COMPLETE MONOGRAPH

2018 GROUP A PUBLIC COMMENT AGENDA

OCTOBER 24 - 31, 2018
GREATER RICHMOND CONVENTION CENTER
RICHMOND, VA

3114.8.5.3(1)
Bracing Unit Distribution--Maximum Linear Length

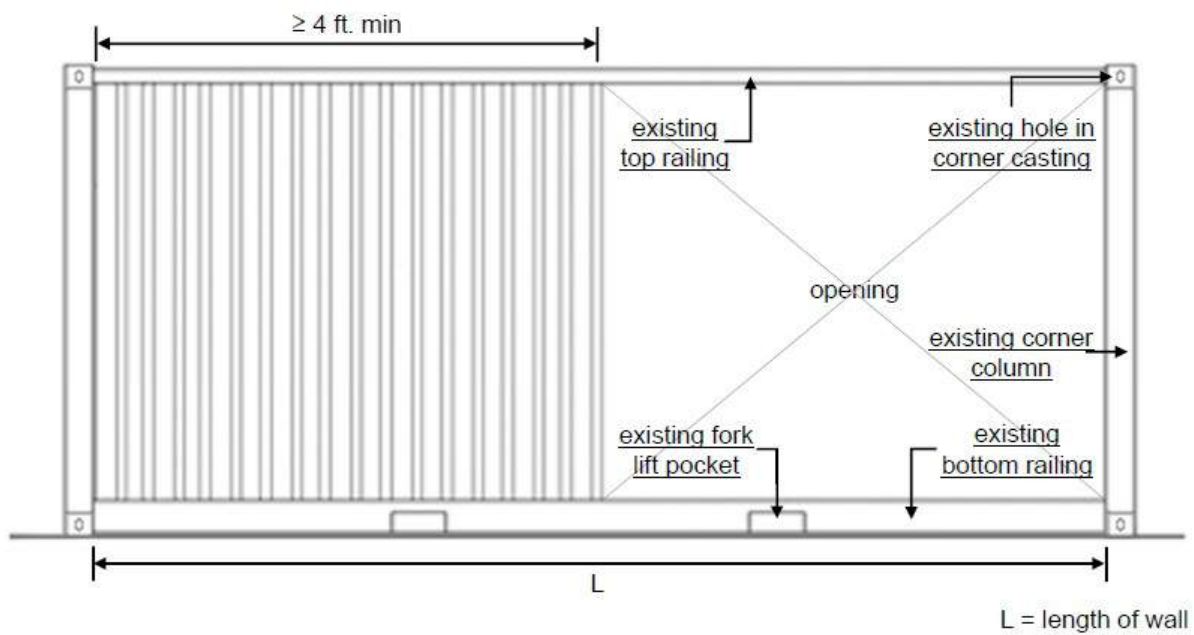
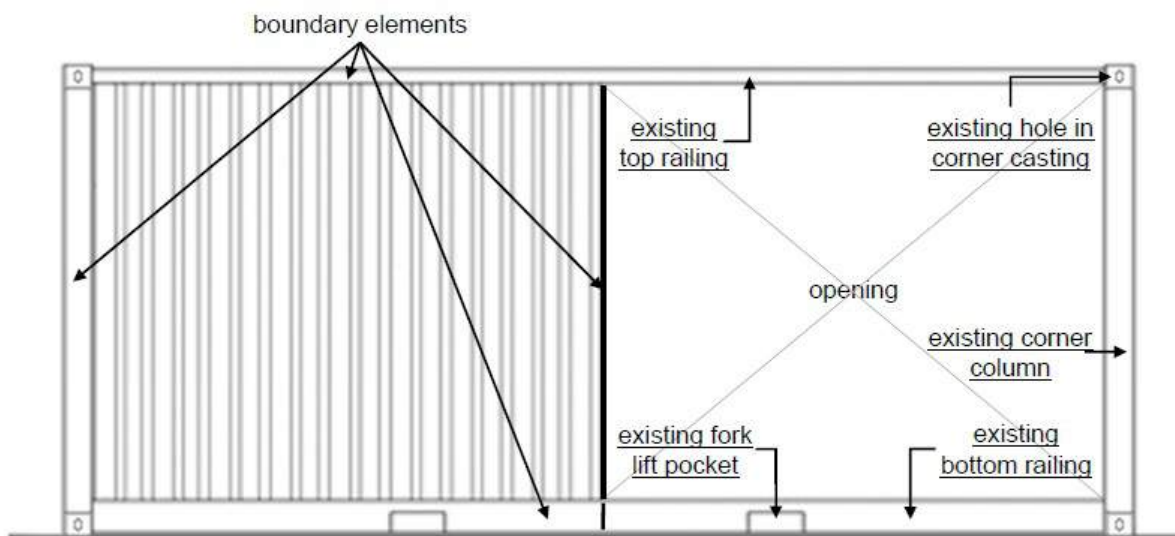
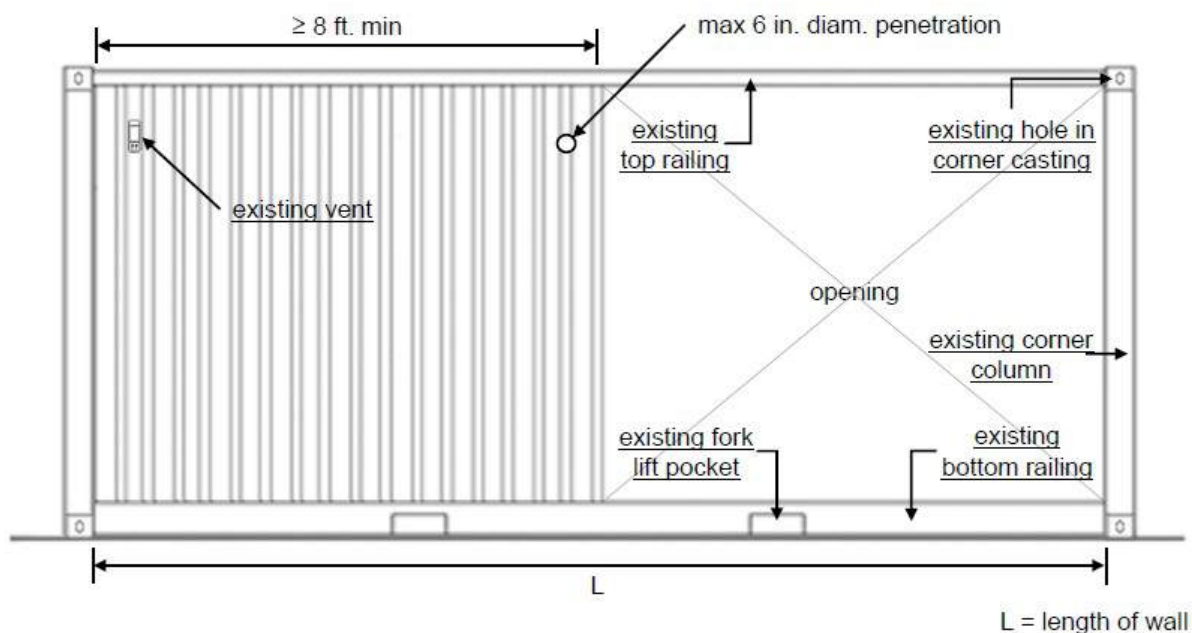
Figures 3114.8.5.3 (1) through (4) - It was brought to our attention that it may be beneficial to identify parts of the intermodal shipping container more clearly rather than use a simple line drawing figure. This is for the benefit of the user to more readily recognize existing conditions versus the permissible cut-aways as allowed by Section 3114.8.5.3. In response we are proposing to add identifying text (the rails, lift slots, and holes) to illustrate those existing elements that are part of the manufacture of intermodal shipping containers.

Fig. 1 – IBC Sec. 1006.3.2 prevents this configuration

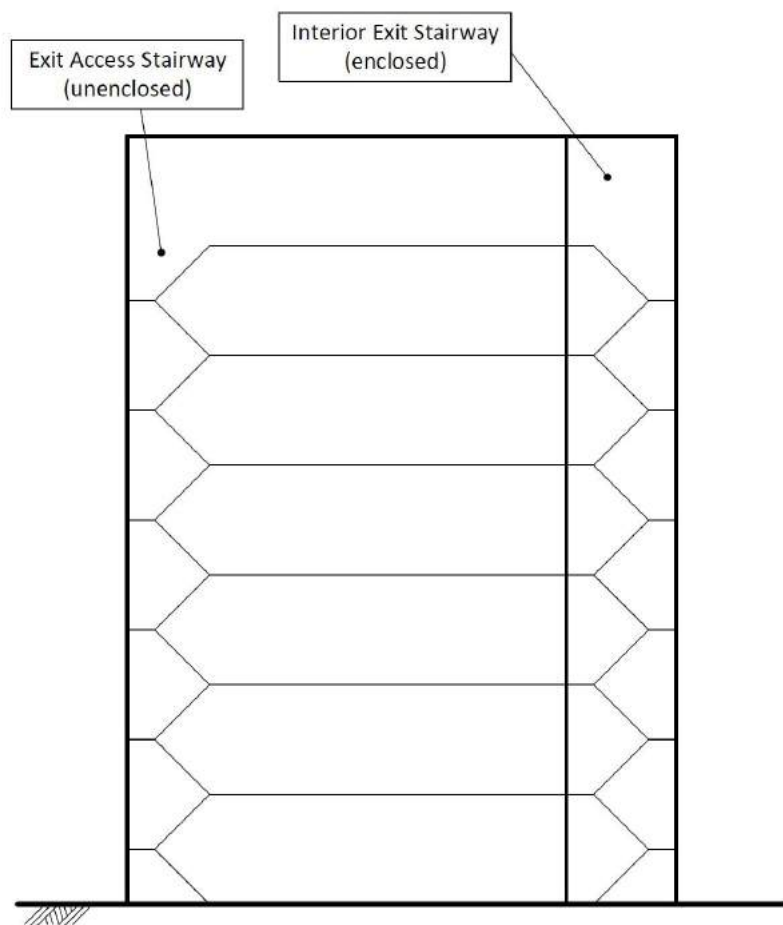
The charging language in Section 1006.3.2 (using the numbering system proposed by this code change proposal) was originally introduced to prevent situations shown in Figure 1 below. This figure illustrates a multi-story building that has one (enclosed) interior exit stair and one (unenclosed) exit access stairway. Prior to the introduction of the code text in 1006.3.2, the code would have allowed this situation in a B or M occupancy. (Recall that in a B or M Occupancy, an unenclosed exit access stairway is not limited in height.)

Fig. 2 - E18-18 As Modified – Occupied Roof Served by Exit Access Stairway

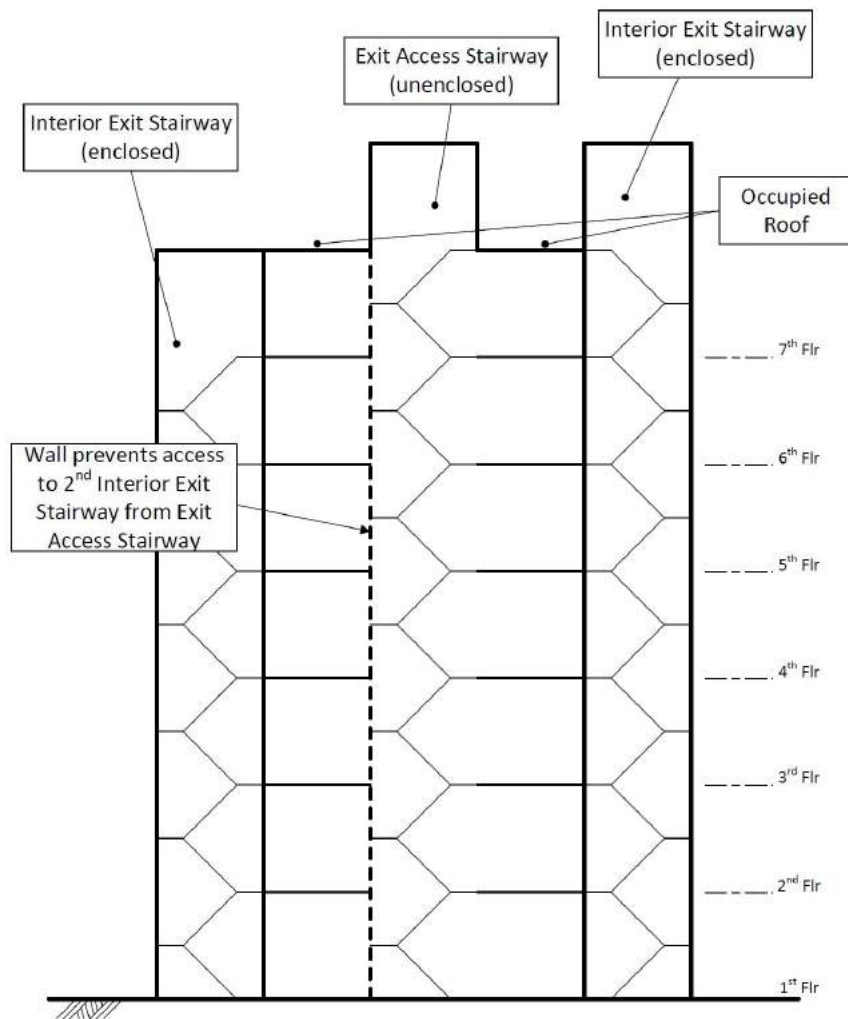
However, this proposal with the floor modification approved by the Committee would allow a similar, dangerous situation for a roof deck, as shown in Figure 2. This figure depicts a multi-story building with an occupied roof. All stories have access to the two interior exit stairs. The occupied roof is served by an interior exit stair (on the right), and an unenclosed exit access stairway. Because the modification introduced on the floor at the Committee Action Hearings in Columbus exempts stairs serving an occupied roof from the shall not pass through more than one adjacent story restriction, this means that the unenclosed exit access stairway is not required to transition to the enclosed exit stair on the left of the figure at the uppermost story. That is, the exit access stair could be isolated from the second enclosed exit stair. This is a dangerous precedent to set, as one could argue if an unenclosed exit access stairway of unlimited height (in a B or M occupancy) is allowed to be the second means of egress for an occupied roof, why should there be any restriction on using the same arrangement for a story?

Fig. 3 - E18-18 As Submitted – Decks on Different Roof Levels

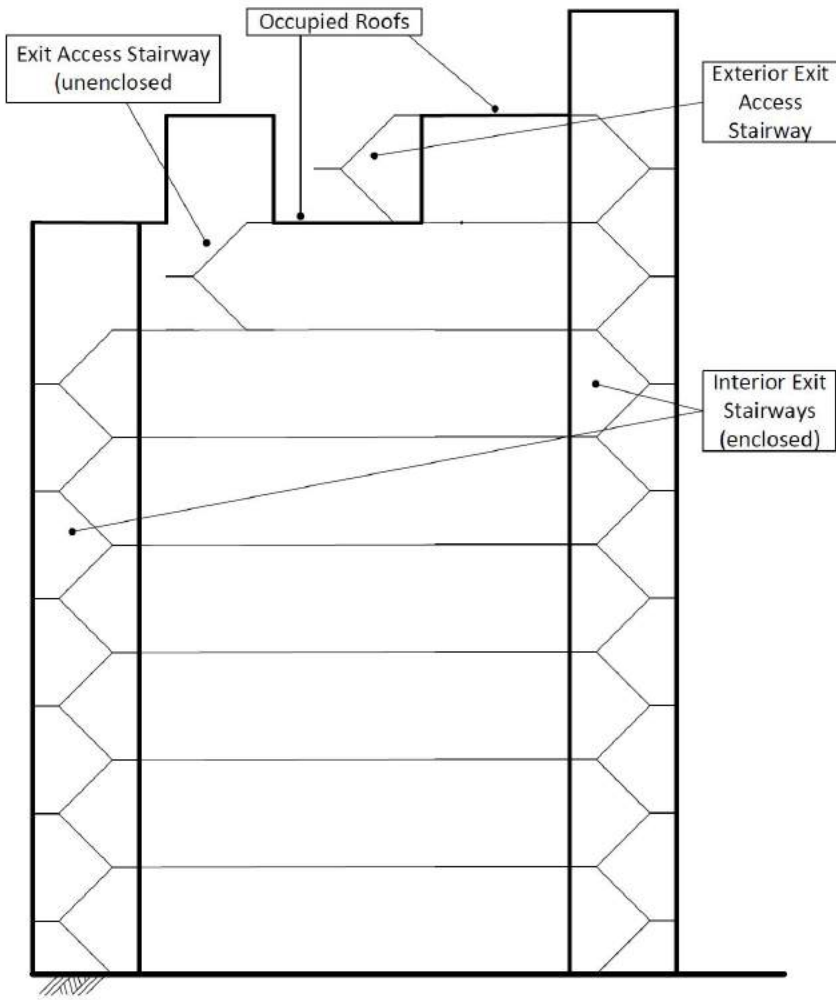
This public comment returns to the originally proposed text of Section 1006.3.2, Exception 7, and Section 1019.3, Exception 9, and keeps them in alignment. We believe the proponent of the original code change had a legitimate issue that is addressed with his proposed language. There are cases of buildings with multiple roof levels with roof decks (Figure 3), or roofs with multiple levels of roof decks (Figure 4) where an exterior stair connecting the occupied roofs need not count toward the one adjacent story, as smoke will not accumulate at those levels.

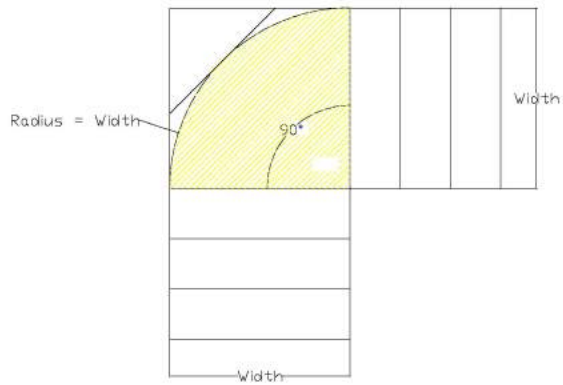
Commenter's Reason: The committee rightly suggested that this exception should be rewritten to clearly state what is intended. As noted in the original supporting statement, the commentary on Section 1011.6 specifically states: *It is not the intent of this section to require that a stairway landing be shaped as a square or rectangle. A landing turning the stairway 90 degrees (1.57 rad) or more with a curved or segmented outside periphery would be permitted, as long as the landing provides an area described by an arc with a radius equal to the actual stairway width [see Commentary Figure 1011.6(3)]. In this case, the space necessary for means of egress will be available.*

The proposed modification will clarify that the landing may be configured to provide the minimum width on a landing by the arc at the minimum width of the stair. Figure 1011.6(3) describes a "reversing run stairway" which is reflected in the proposed code text.

FIG. 1 – F117-18 – CORNER VS MID-BLOCK LOT

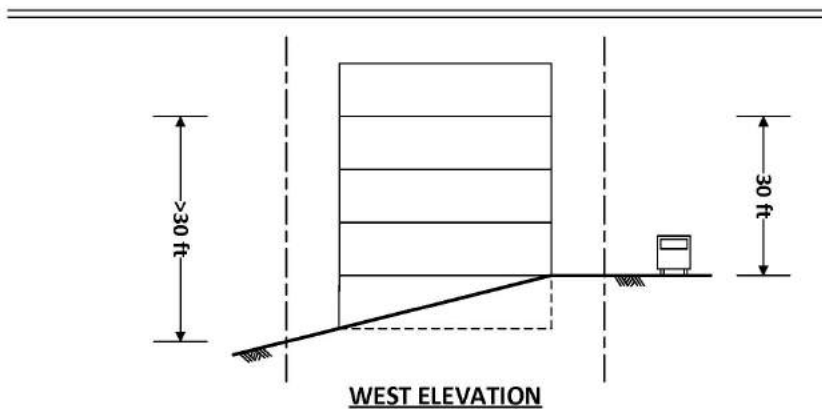
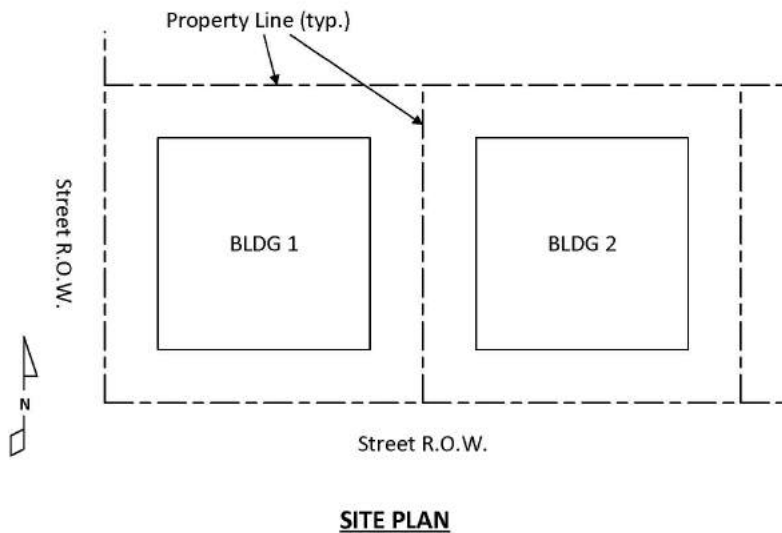
Siu: Our objection to this proposal is that by measuring to lowest fire department vehicle access, it penalizes buildings built on downsloping corner lots. Figure 1 below depicts two identical buildings built side-by-side, fronting on a level street (site plan). Both lots have identical slopes downward from the street (west elevation). Building 2 is built mid-block; Building 1 is built on a street corner. Because lowest fire department vehicle access for the Building 1 is measured from the sloping side street, its measurement datum is lower than the mid-block building, which is measured from the fronting street. Based on the measurements shown in the figure, this proposal would trigger a full NFPA 13 system for the Building 1 whereas the Building 2 could use an NFPA 13-R system, yet in all ways except location, the buildings are identical. Note that it can be argued that Building 1 has better fire department access (two sides) than Building 2. It seems that if Building 2 is considered to be safe, the Building 1 should not be penalized for its corner location.
